Inspecting Architects Report on Proposed New Central Heating Boiler The Church of the Ascension Hall Green

Issue date: June 2018
Prepared by: LZC
Checked by: CXT

New flue marked X

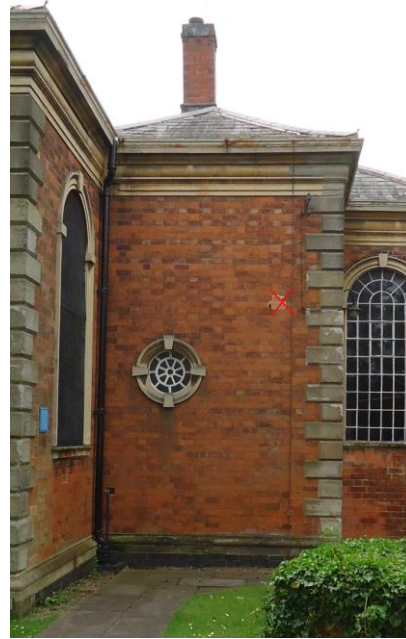
The balanced flue will probably require Listed Building Consent. We recommend therefore that the external parts should be powder coated to match the facing brick colour. We also recommend that its installation be used to relocate the existing header tank immediately below it and to make good the poor quality pointing where the overflow pipe was installed.
